Open electrical issues

Piers Dawe

Mellanox

My list of list of what needs to be done in 802.3bs before that project can be complete

1. Jitter specs for 400GAUI-8 and 400GBASE-DR4 are not compatible

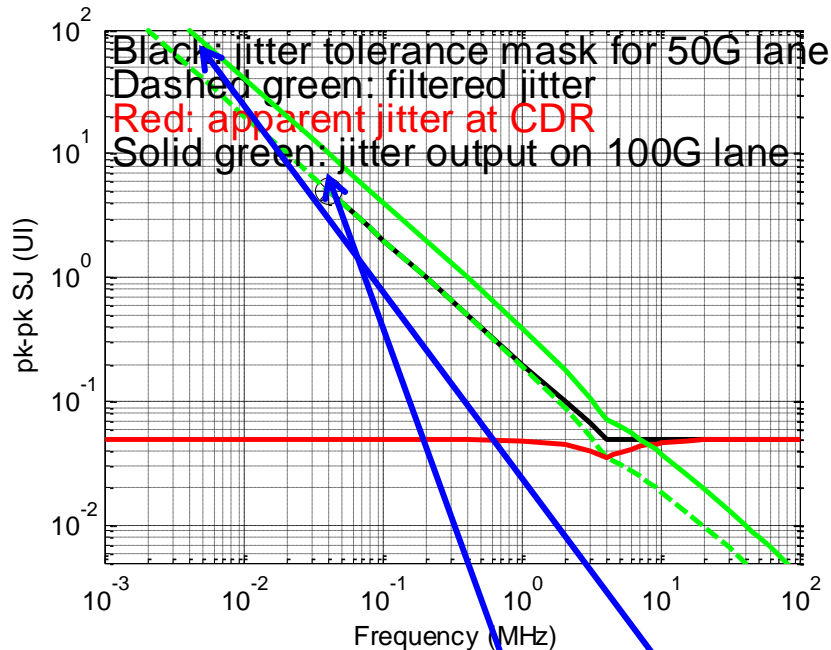
- Module with 400GAUI-8 electrical input, 400GBASE-DR4 optical output
- The module's electrical input can be tested at six SJ points on the mask on the left
- The host's output jitter must be near or below the (extrapolated?) mask
- This is also the jitter mask for the 100G optical lanes, but 1 UI is different there

1. Jitter specs for 400GAUI-8 and 400GBASE-DR4 are not compatible

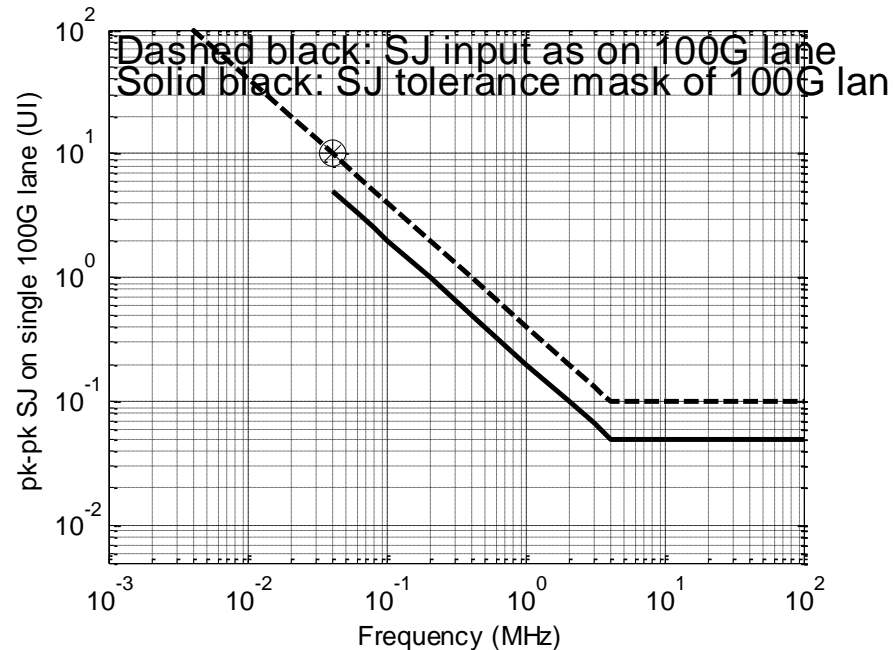
- Module with a conventional CDR (with minimum bandwidth) transfers jitter at low f (dashed green), blocks jitter at high f (electrical signal appears to the module to have the red jitter)
- 1 UI out (100G optical lane) is half as long as 1 UI in (50G electrical lane); the early or late bits from two lanes have to be sent out on one lane

- So the jitter after the input CDR (solid green line) is twice what is allowed
 - with CDR bandwidth tolerance, even more
- Add a FIFO and a second PLL. This costs power and requires a low noise second PLL
- How large a FIFO? 5 UI / lane? 50 UI / lane? 500 UI / lane? More?
- The spec doesn't work

1. Jitter specs for 400GAUI-8 and 400GBASE-DR4 are not compatible

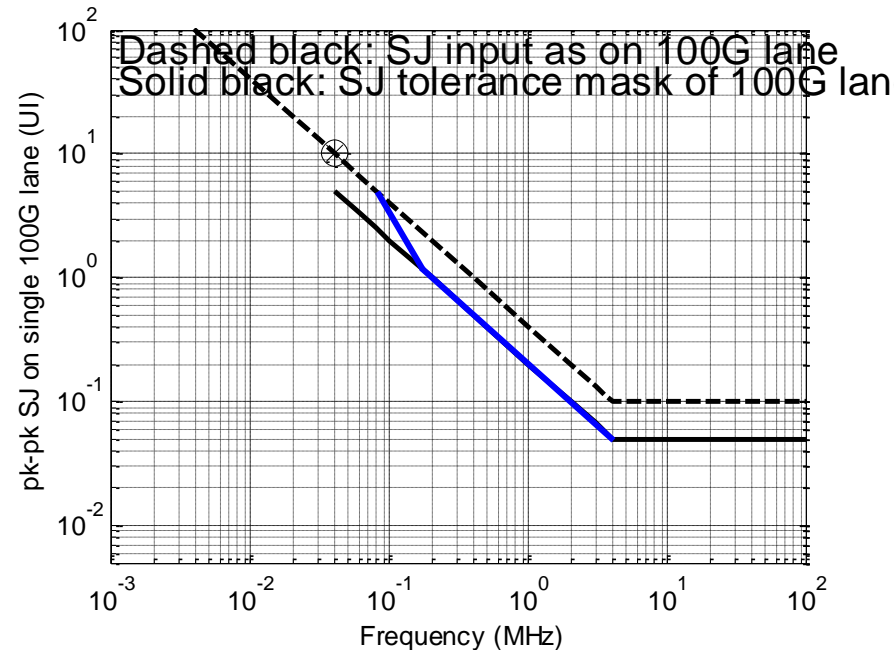
- The two lines are the wrong way round at low frequencies
- Need to make the solid line equal or higher than the dashed line at low frequencies
 - this was hinted in ghiasi_3bs_01a_0116
- There may be more than one way to do this

- One way would be to modify the 100G jitter tolerance mask and reference CRU as the blue line

2. C2C needs a channel RL spec

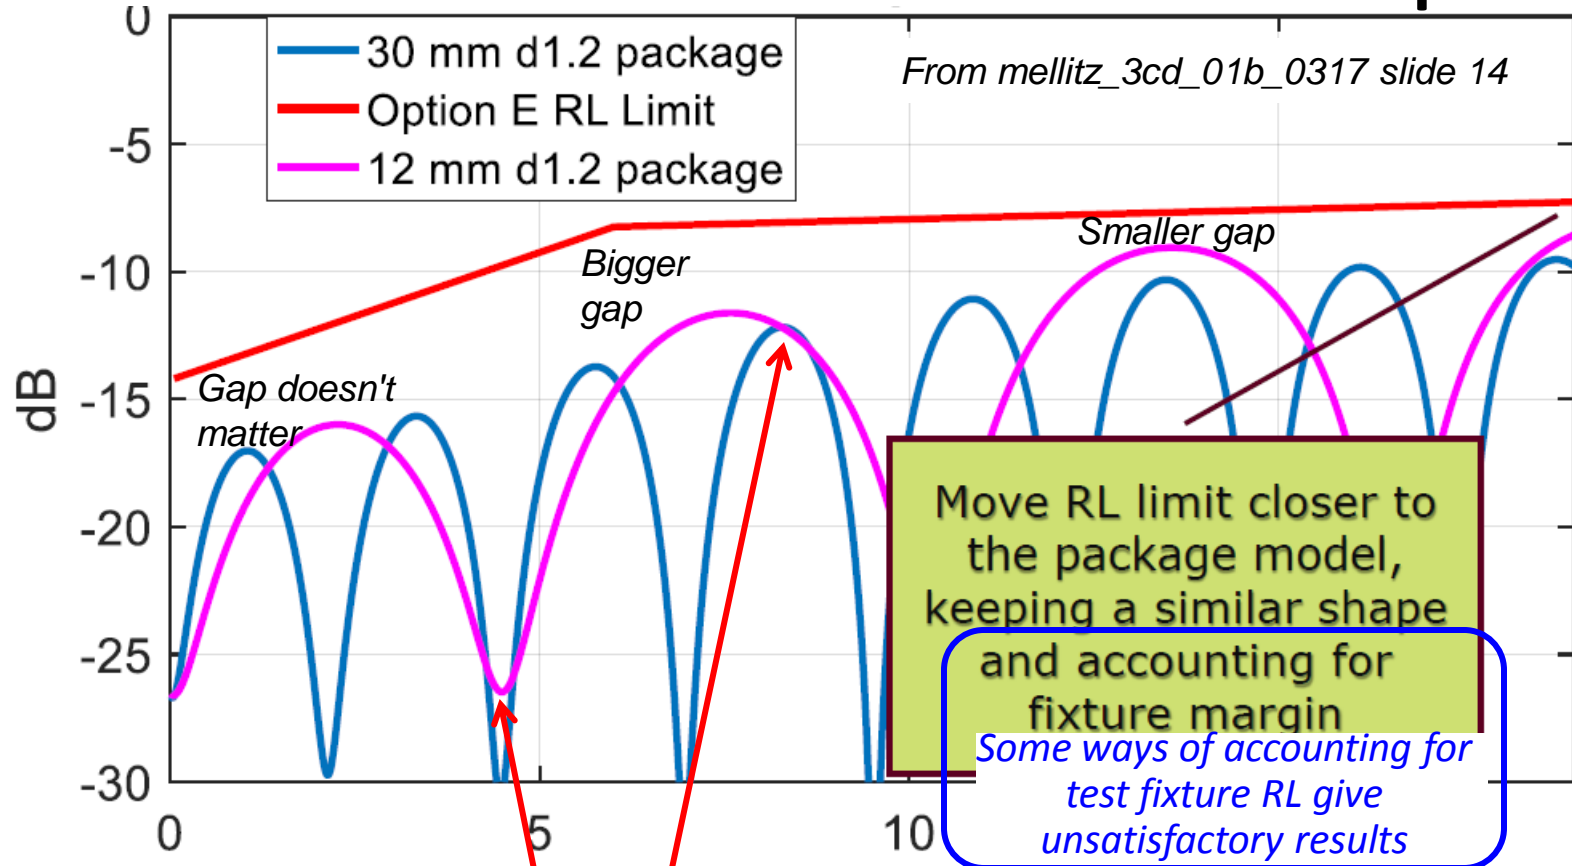
- For much the same reason we have a Tx return loss spec – to control echoes between e.g. Tx and channel that cause ISI that COM does not know about
 - See `dawe_3bs_02_0517` for some initial calculations on this
 - It turns out that the end-to-end reflections are insignificant in comparison; except for channels with minimal loss, the channel insertion loss, which appears twice in an echo path, makes them much smaller than end-to-channel reflections.
At very low frequencies they could have equal spectral density, but few hertz, and in practice at very low frequencies the channel RL is much better than -12 dB
- For practical RL limits, it seems that the 5-15 GHz range is the important area

2. C2C needs a channel RL spec

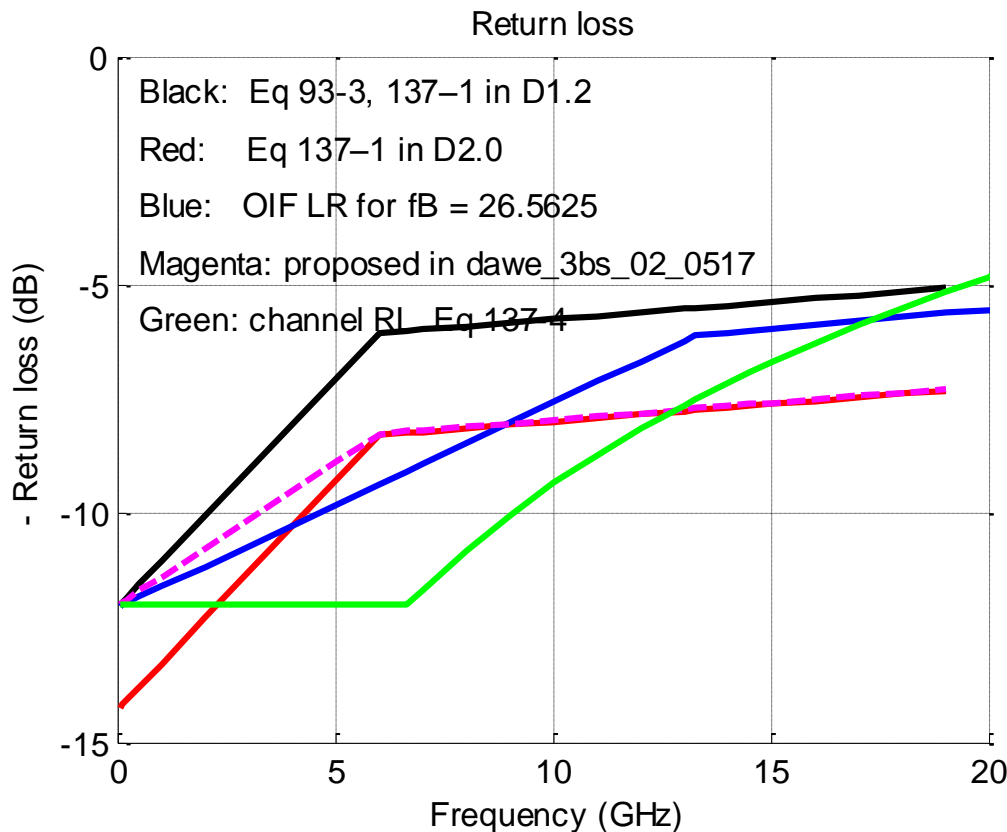
- A channel reflection at this frequency degrades that channel's long-package COM
 - as it should
- A channel reflection at this frequency is pretty much ignored by COM
 - gap in the spec
- We could add more COM package lengths, but...
- A channel RL spec is useful because it treats reflections consistently with frequency

Showing the Clause 137 channel return loss limit

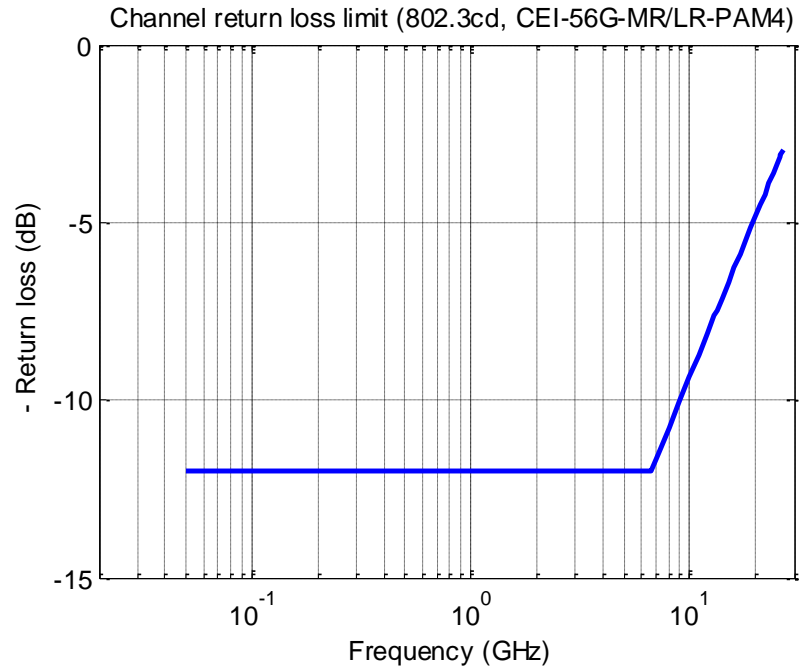
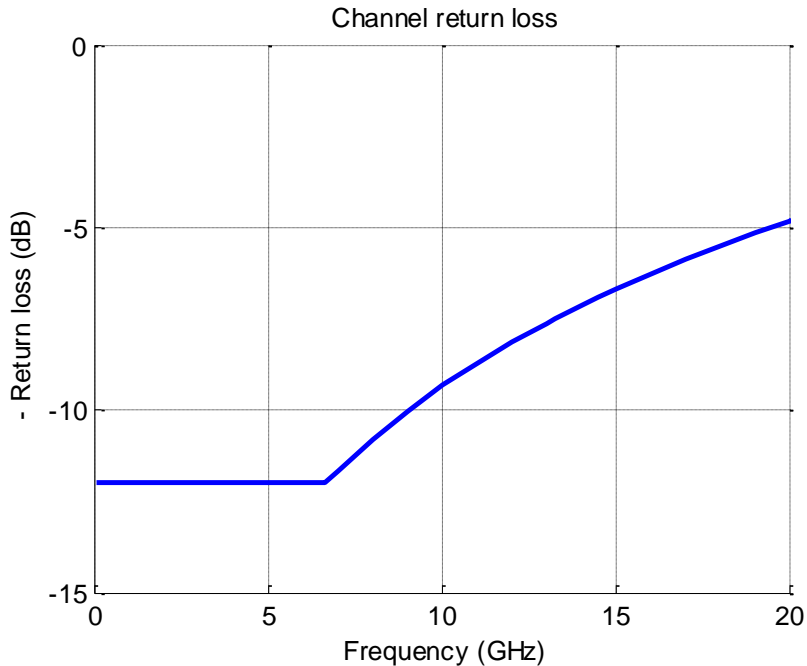
- Channels have lower return loss than this at very low frequencies – but that doesn't mean we need to adjust the spec there
- Should any C2C channel RL spec be the same as Cl. 137 -KRn?
- Should it apply to all channels, or e.g. only if $COM < 4$ or 5 dB?

Channel return loss

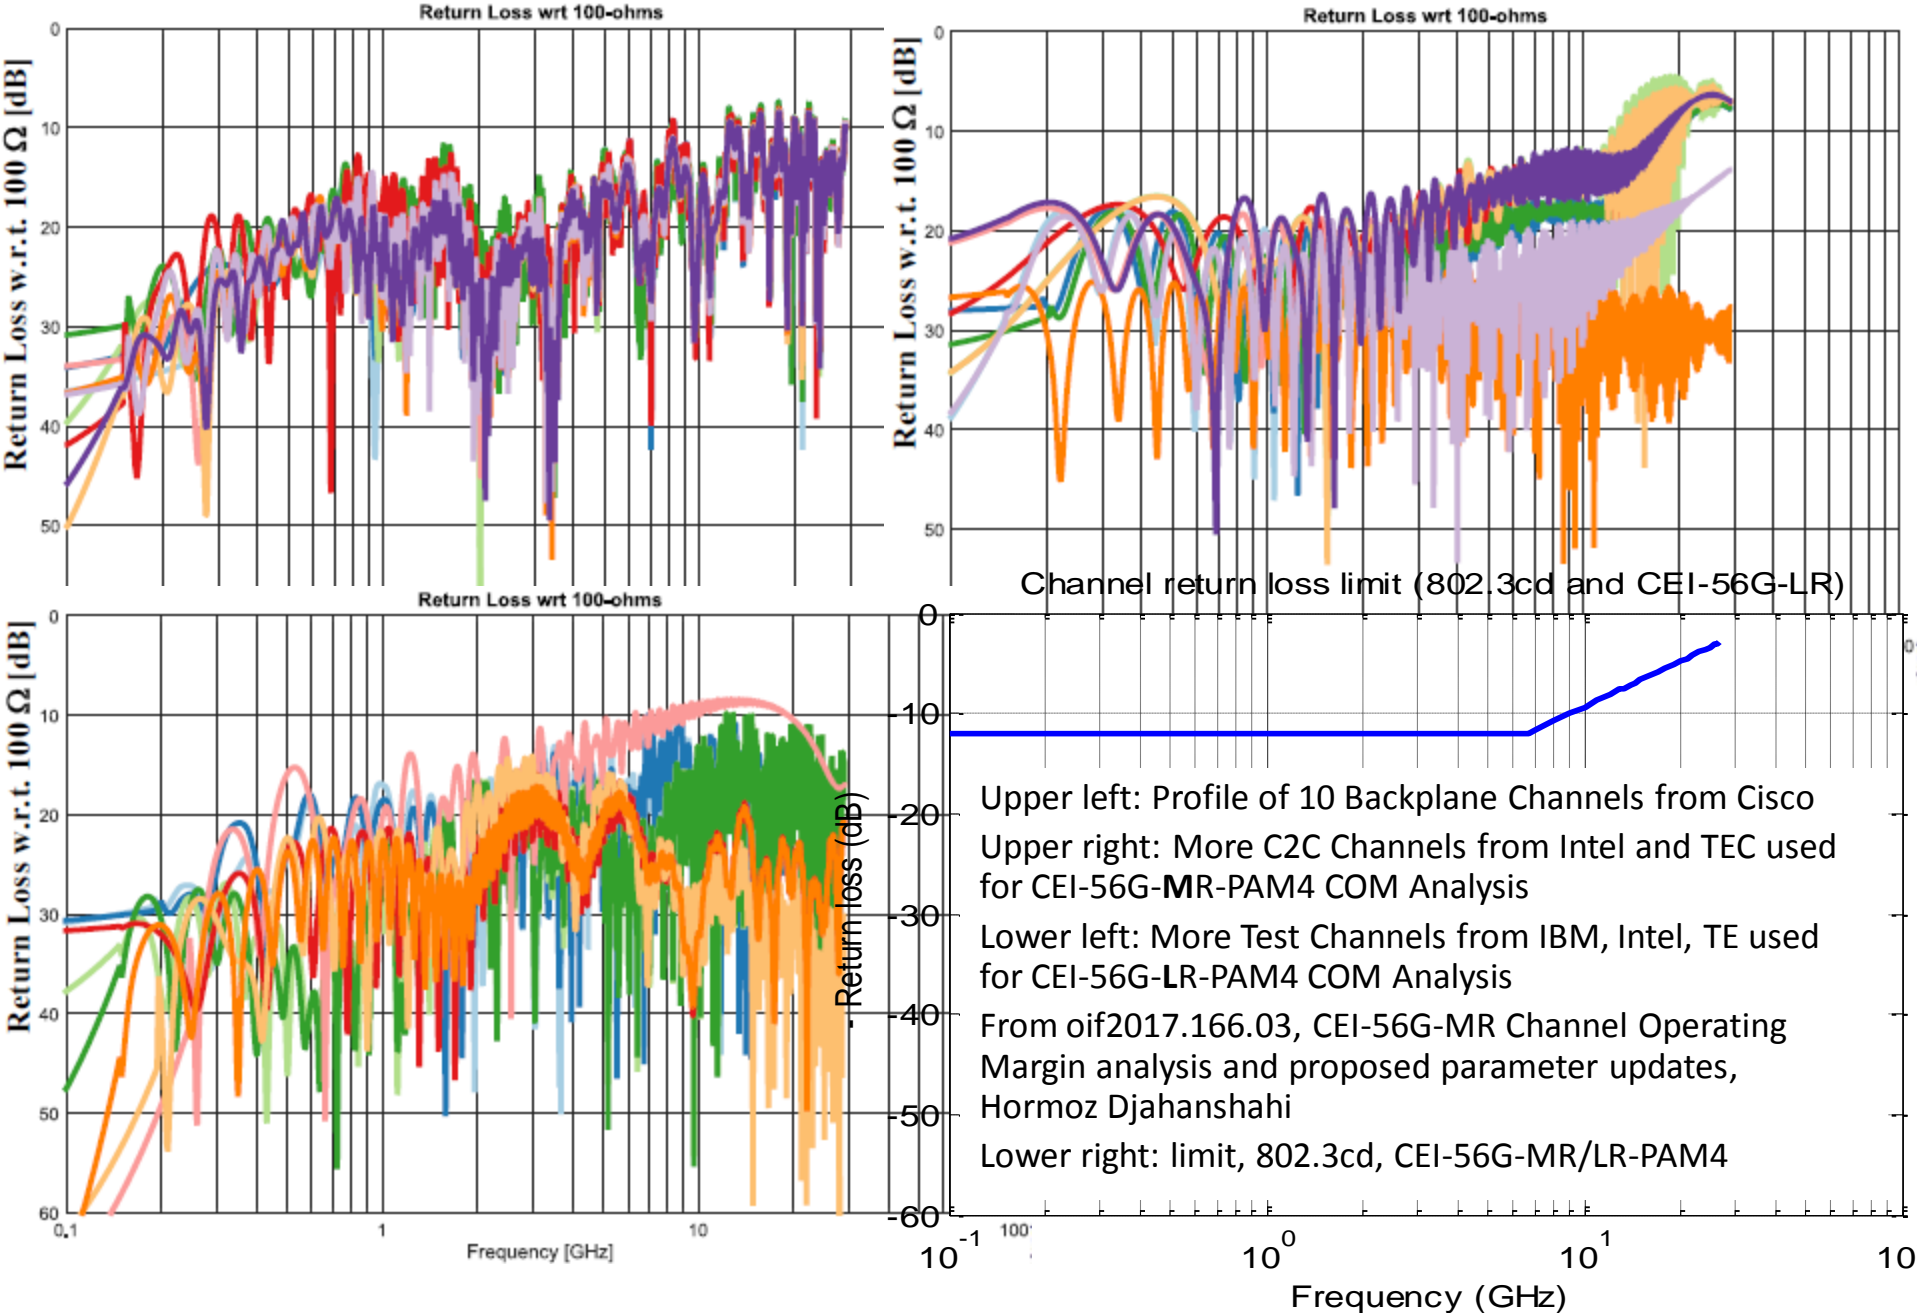
- Channel return loss (at TP0 or TP5) from 802.3cd Eq. 137-4 and OIF
- CEI-56G-MR-PAM4 Eq 17-3 and LR-PAM4 Eq 21-3 (*but not C2C*)
- *C2C needs a channel RL spec, otherwise the Tx RL spec is not very useful*
